ROADWAY AND STORM SEWER CONSTRUCTION PLANS
FALCON MEADOWS AT BENT GRASS FILING NO. 4
FALCON, CO 80831 - EL PASO COUNTY
CHALLENGER COMMUNITIES, LLC

GALLOWAY RESPONSE TO COMMENTS IN BLUE BOXES WITH WHITE TEXT

WATER AND WASTEWATER CONSTRUCTION PLANS
FALCON MEADOWS AT BENT GRASS FILING NO. 4
FALCON, CO 80831 - EL PASO COUNTY
CHALLENGER COMMUNITIES, LLC

LEMON GRASS ROAD (STREET L) – PUBLIC 50' R.O.W.
25 MPH DESIGN SPEED (LOCAL)

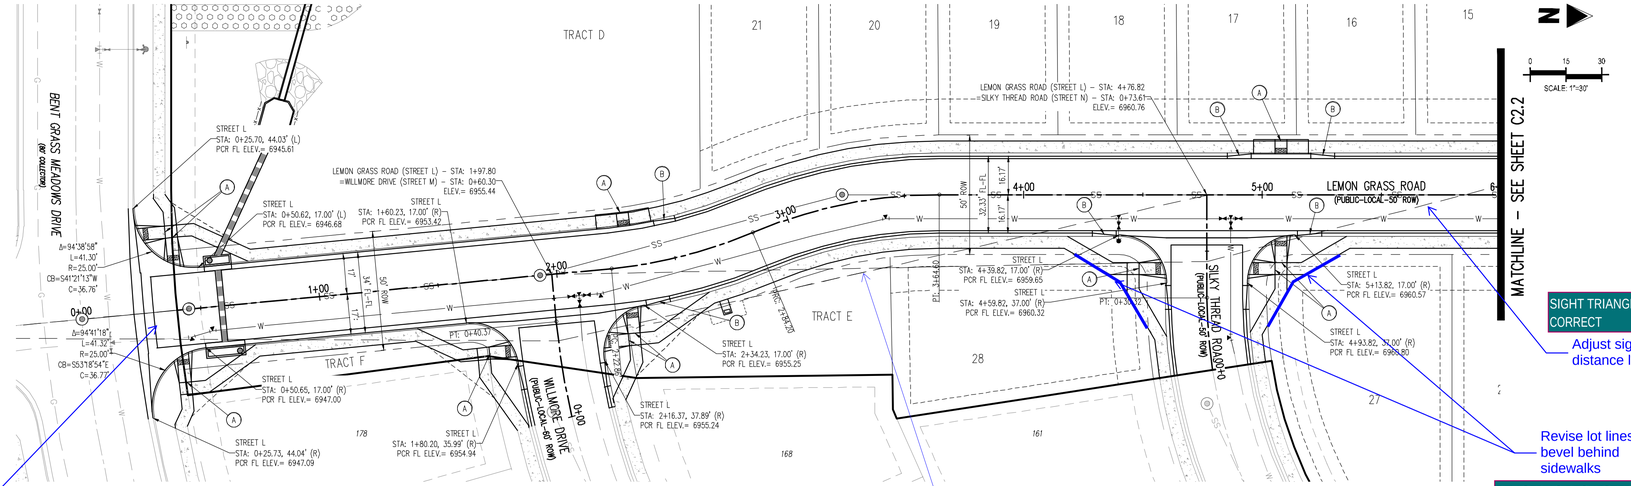
Label features to be removed

Revise lot lines to bevel behind sidewalks

EXISTING CONDITIONS & DEMOLITION PLAN HAS BEEN ADDED TO THE SET TO SHOW ALL FEATURES BEING REMOVED

REVISED AS REQUESTED

SIGHT TRIANGLE IS CORRECT

REVISED AS REQUESTED - LOT 28 HAS BEEN RELOCATED ACCORDING TO REPLAT

LEMON GRASS RD
IMPROVEMENT PLAN

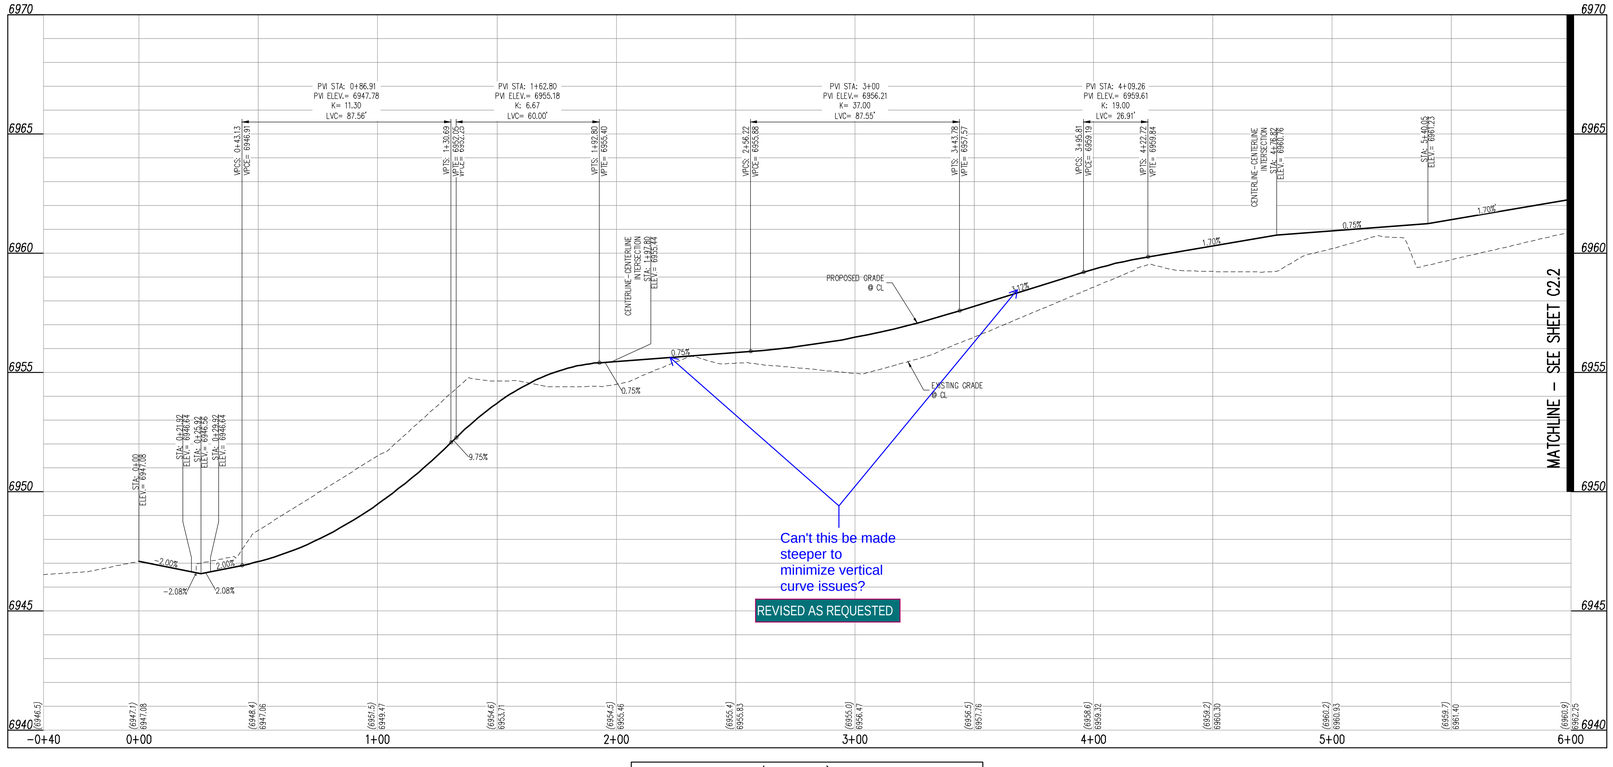
Can't this be made steeper to minimize vertical curve issues?

REVISED AS REQUESTED

LEMON GRASS ROAD (STREET L) – PUBLIC 50' R.O.W.
25 MPH DESIGN SPEED (LOCAL)

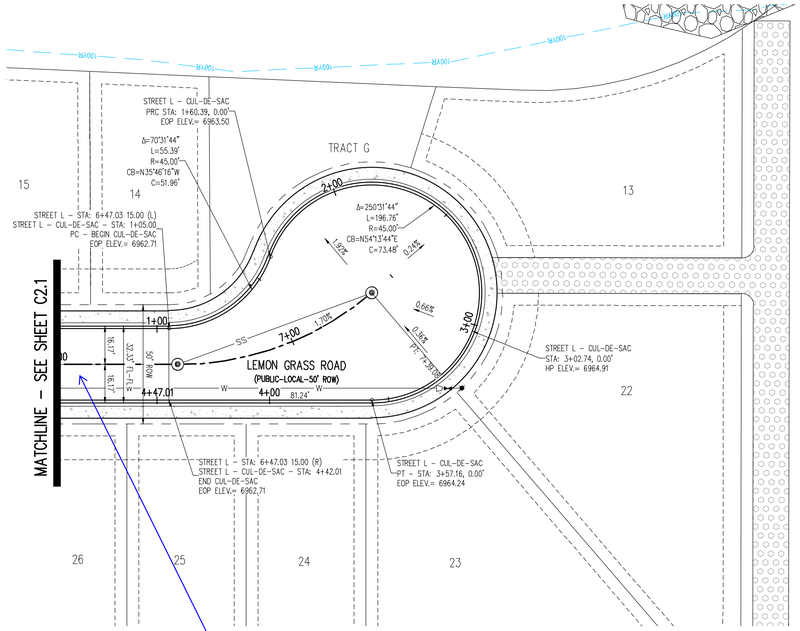
Show sight distance line

REVISED AS REQUESTED

STREET M
STA: −0+50 – 1+00
SCALE: H: 1"=30' V: 1"=3'

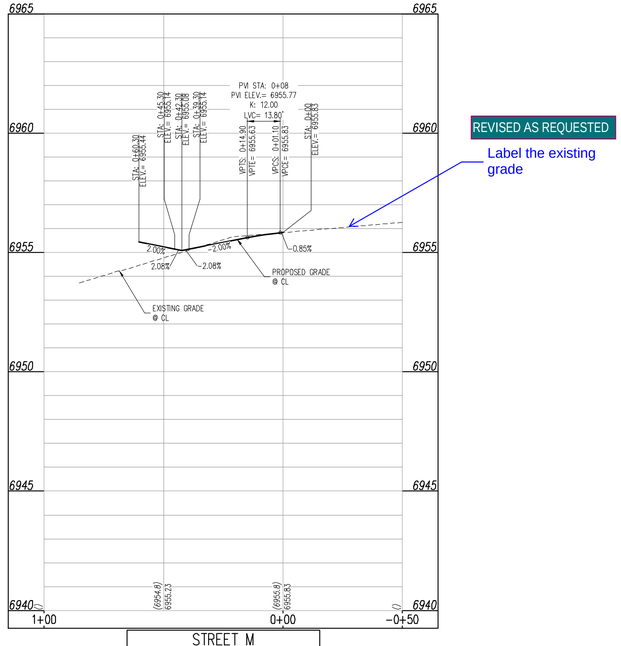
Label the existing grade

REVISED AS REQUESTED
